## **ADDENDUM #2**

DATE: September 16, 2016

TO CONTRACT DOCUMENTS ENTITLED: Biotech Connector  
1901 N. 21<sup>st</sup> Street  
Lincoln, Nebraska

**E2.02**

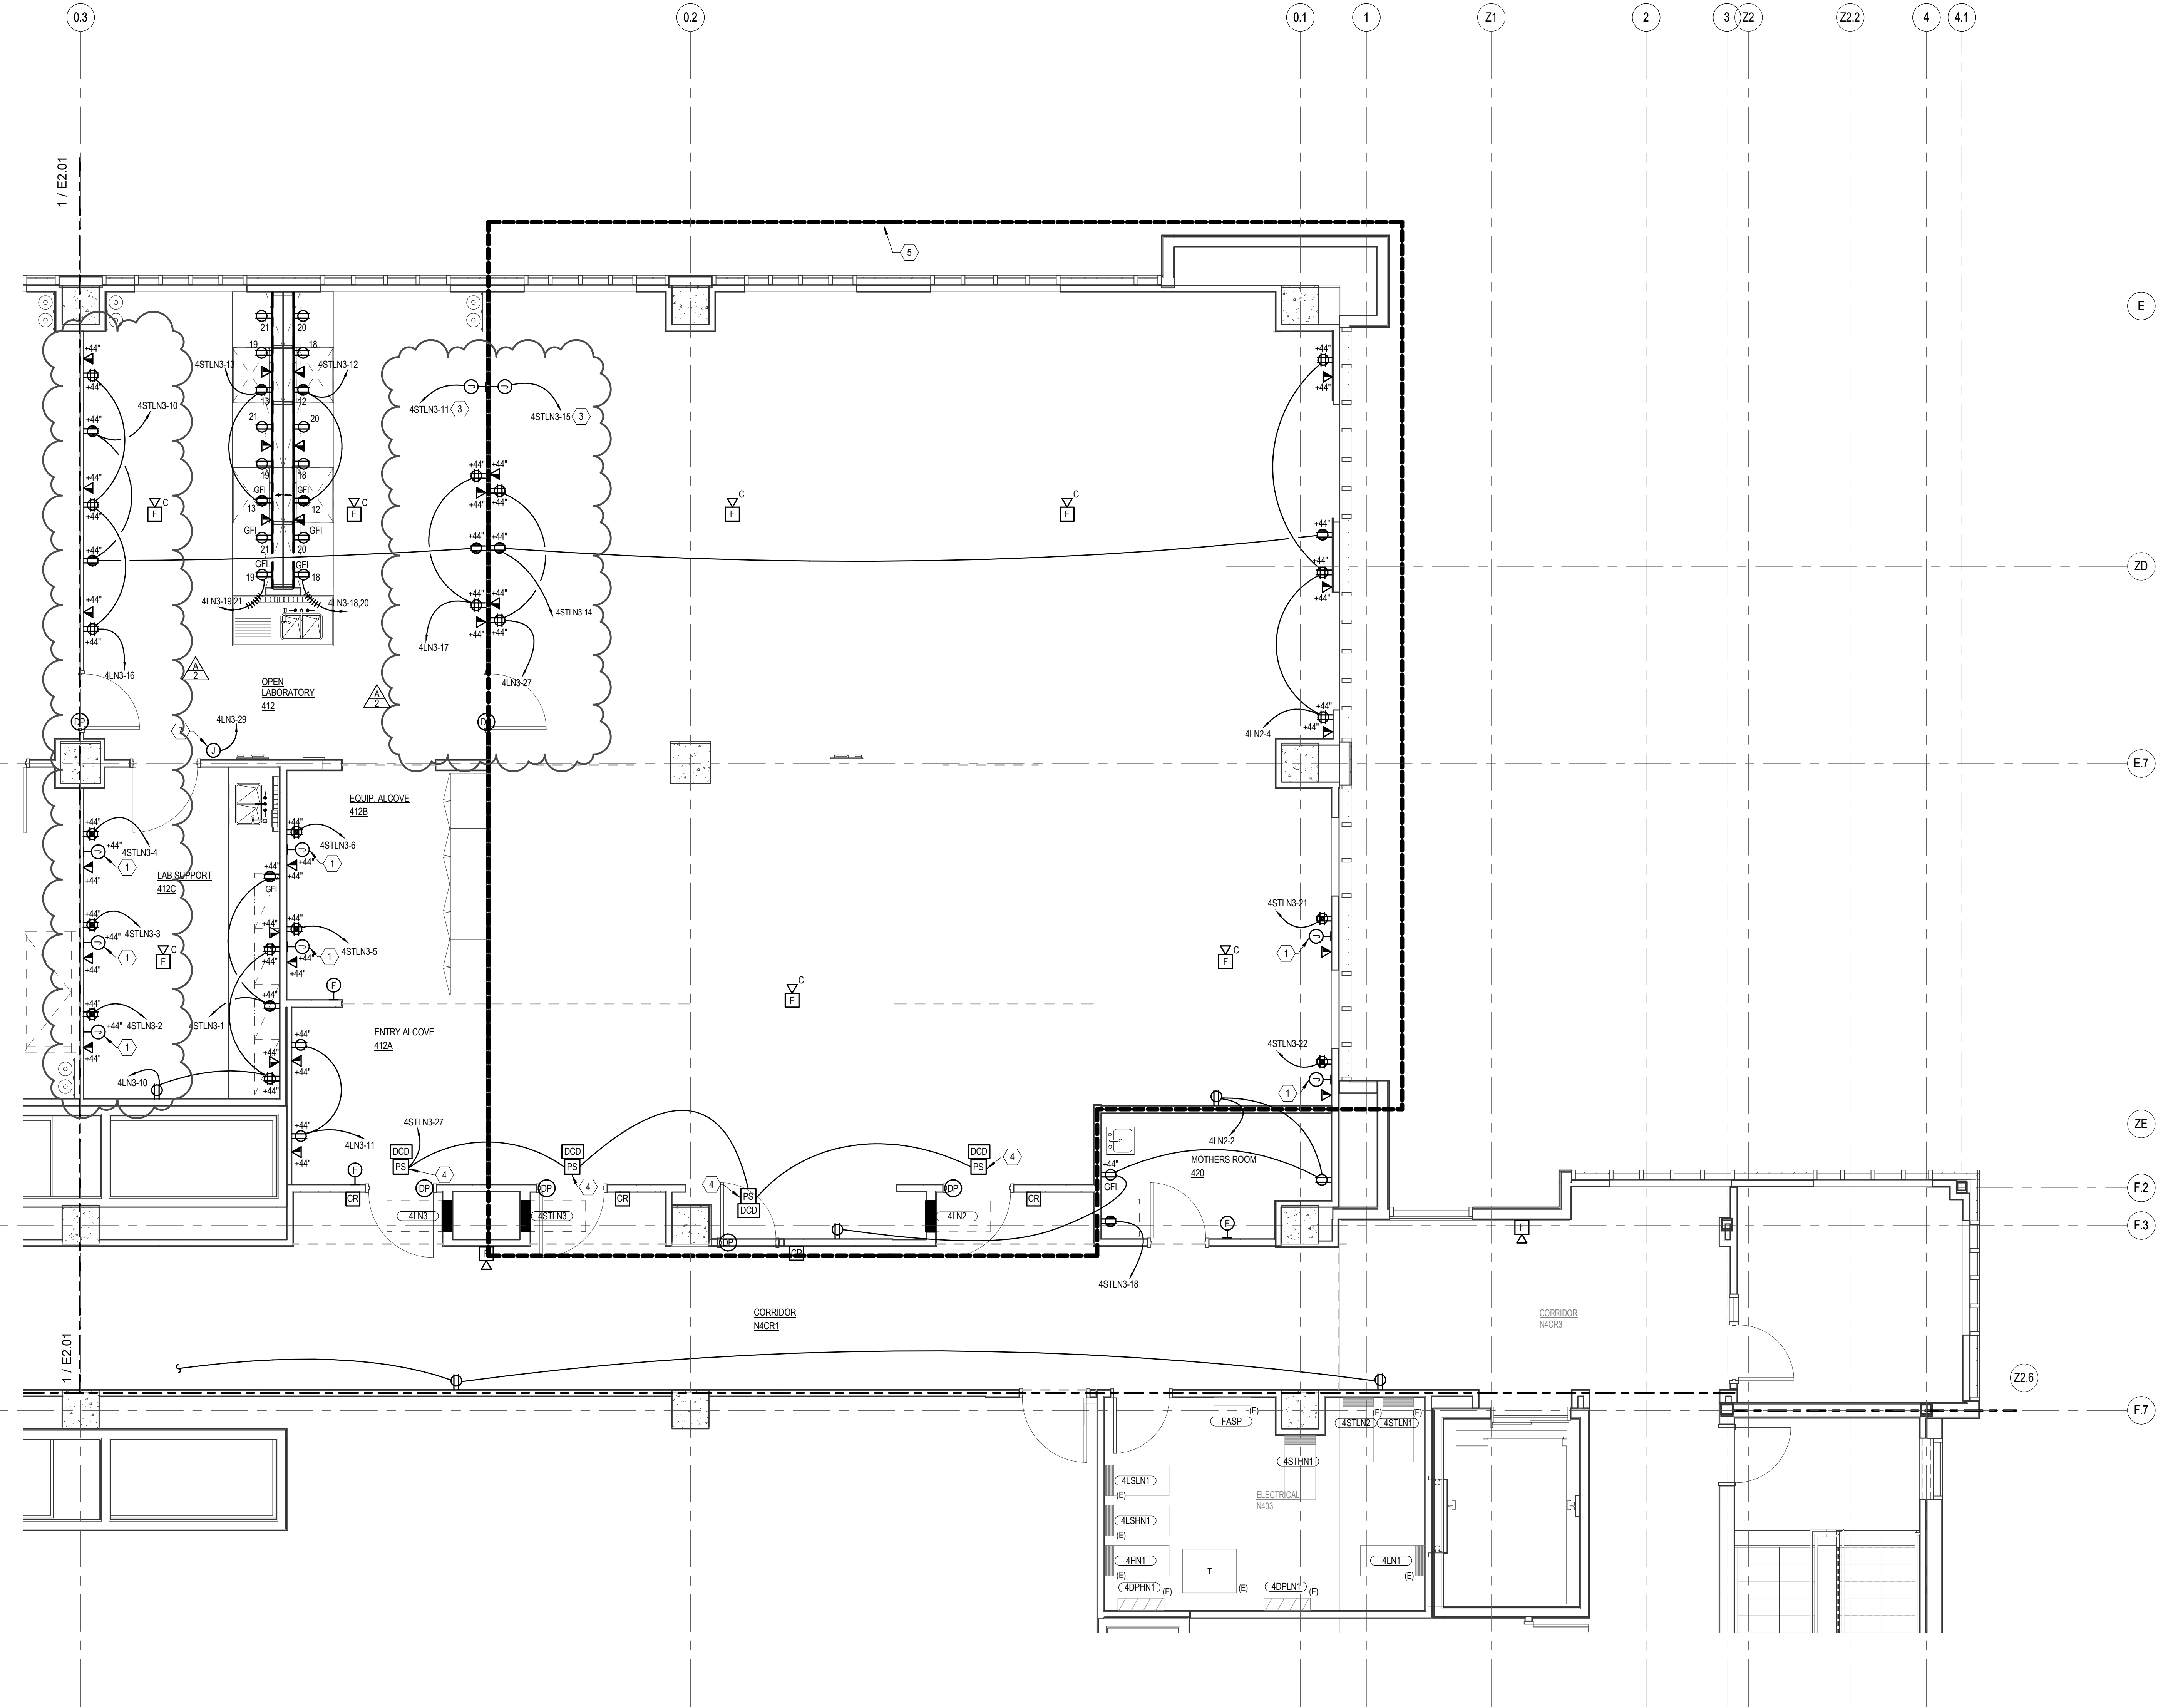
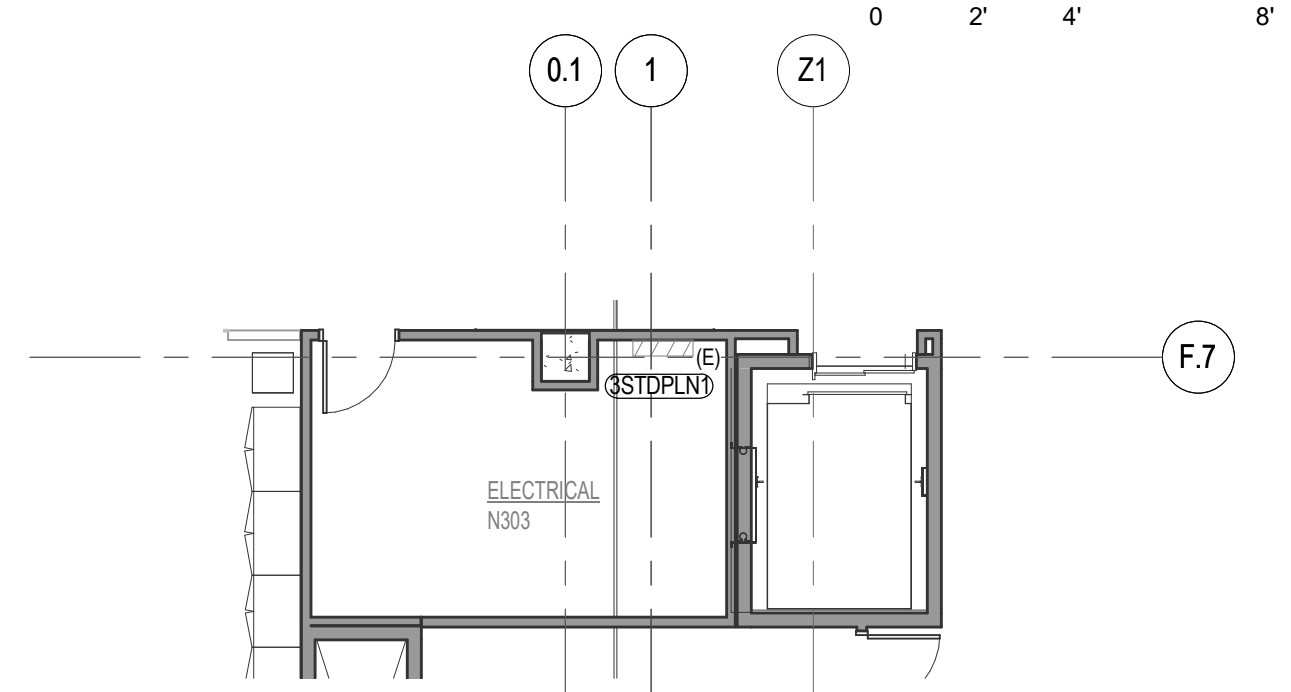
Surface mounted devices have been recessed in demountable walls. See the attached sheet E2.02 for additional information.

IF ALTERNATE #6 IS ACCEPTED, ALL SERVICES SHOWN IN DEMOUNTABLE WALLS SHALL BE RECESSED.

**E2.03**

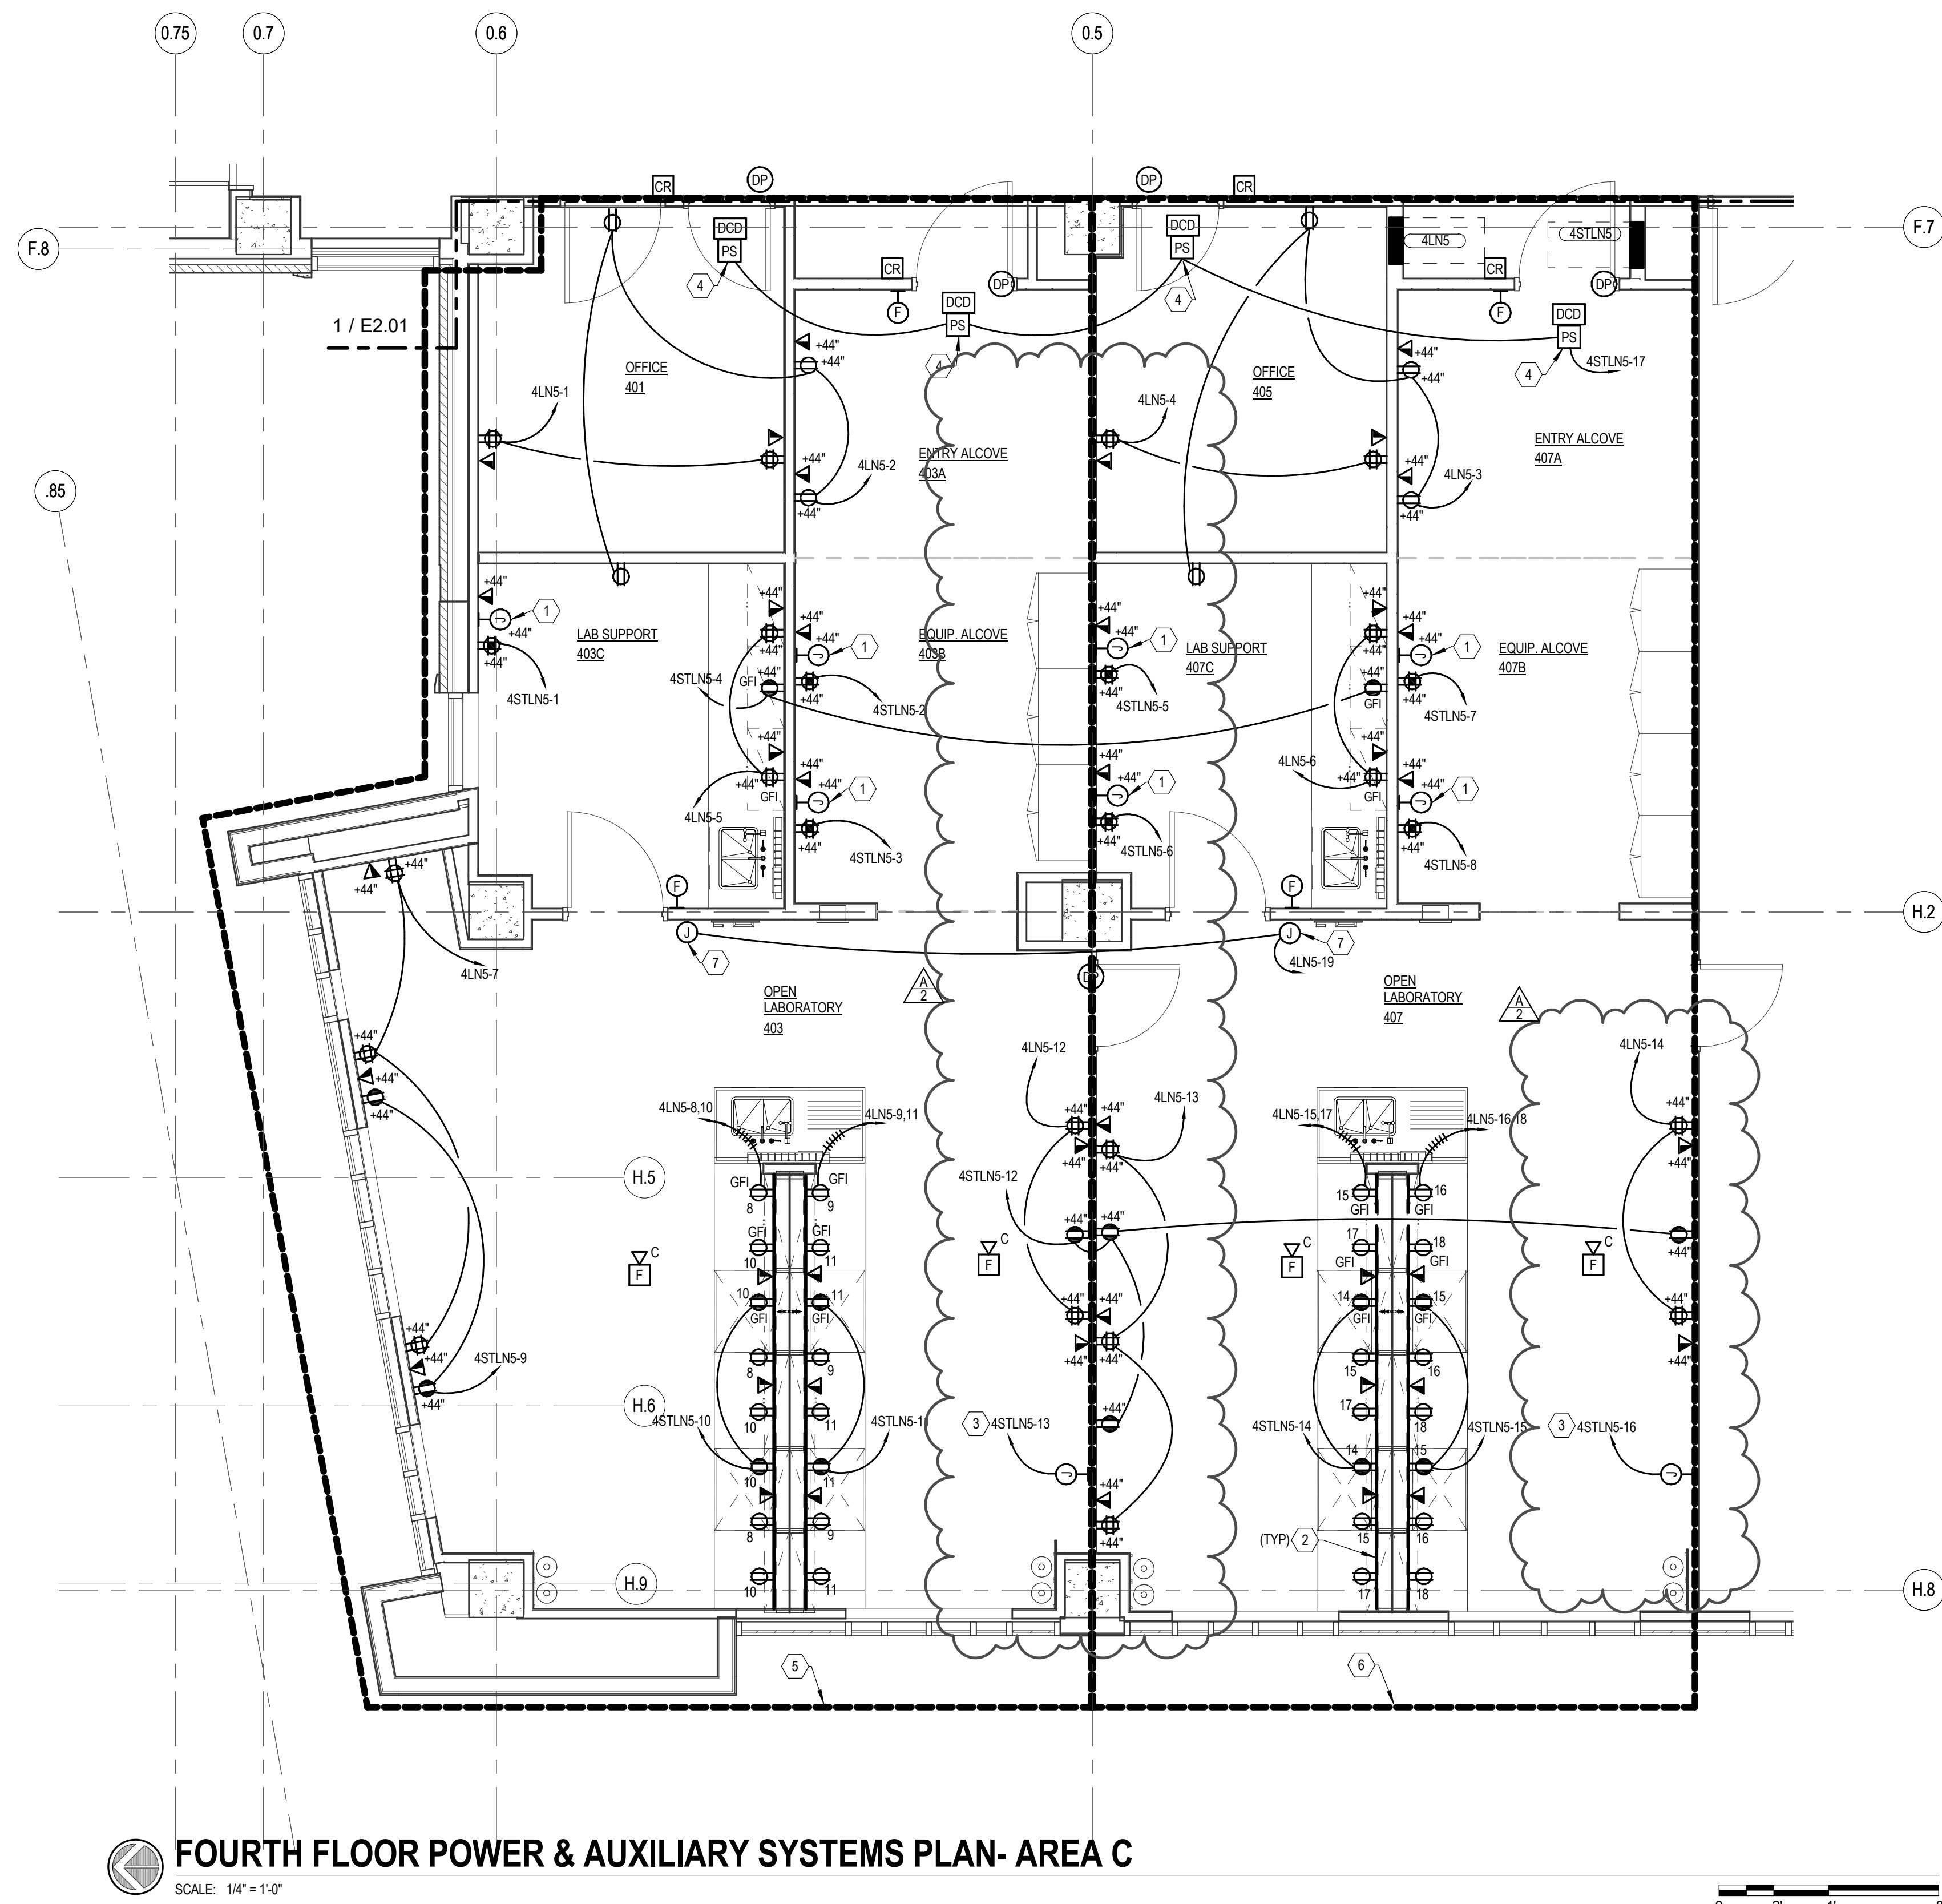
Surface mounted devices have been recessed in demountable walls. See the attached sheet E2.03 for additional information.

IF ALTERNATE #6 IS ACCEPTED, ALL SERVICES SHOWN IN DEMOUNTABLE WALLS SHALL BE RECESSED.
